PUBLIC HEARING/WORKING SESSION MEMORANDUM

PETITION #261-16

1-55 Boylston Street

Request for Special Permit/Site Plan Approval to allow site and building improvements including constructing new buildings to allow for existing and new commercial uses consisting of banking, office, medical office, theatre, health club, retail, restaurant and parking, to allow buildings in excess of 20,000 sq. ft., allow a building 60' in height, site plan review for buildings within 300' of a great pond, allow parking within a setback, extend farmer's market special permit #230-14, update signage special permit #417-12, allow some parking stalls of the site to be reduced in size and in garage to be reduced stall depth, allow reduced parking facility lighting and grant exceptions for parking stall size and interior landscaping requirements

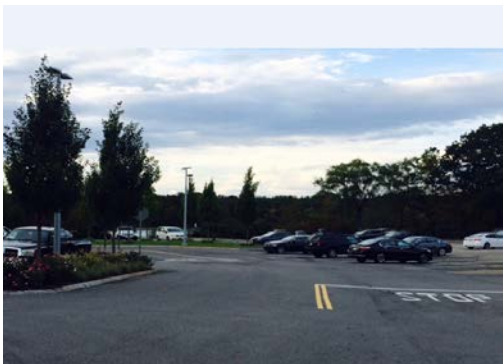
contains a provision for development near a great pond. Per Section 5.6, “No building, structure or alteration, enlargement or extension located within 300 feet of a great pond defined under M.G.L. Chapter 131, Section 1 shall be permitted other than under the procedure in Section 7.4 with particular concern to the preservation of public view, enjoyment and access to the great pond.” The petitioner has submitted a plan of the site showing all proposed development within 300 feet of Hammond Pond (**Attachment A**). Below is a quick summary of the proposed construction within the 300 foot buffer with existing and proposed renderings:

- *55 Boylston Street:* The petitioner is proposing two infill locations at this location which are within the 300 foot buffer. The existing structure is two stories with a movie theatre and retail on the second floor and a drive aisle with parking underneath. The petitioner is proposing 8,400 total square feet of infill on the northeastern façade of the structure to allow for a restaurant with outdoor seating on the second floor and increased retail on the ground floor. The petitioner is also proposing 4,700 square feet of infill on the ground floor of the western façade to create more retail space. Staff suggests the petitioner provide a rendering of this infill on the western façade prior to the next public hearing.

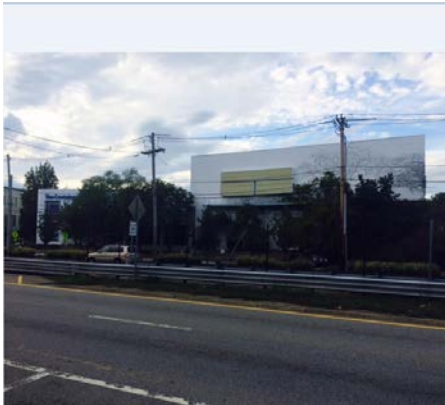
- *Pond Buildings:* The petitioner is proposing to construct two structures, as well as a boardwalk, over existing impervious surface. The proposed structures are 20 feet tall and are 1,900 and 7,900 square feet.

- *27 Boylston Street:* The petitioner is proposing a two story 84,000 square foot structure with two levels of parking beneath. The structure will have two “wings” separated by a pedestrian plaza which will allow access to both wings of the structure. The Planning Department notes approximately half of this structure is within the 300 foot buffer.
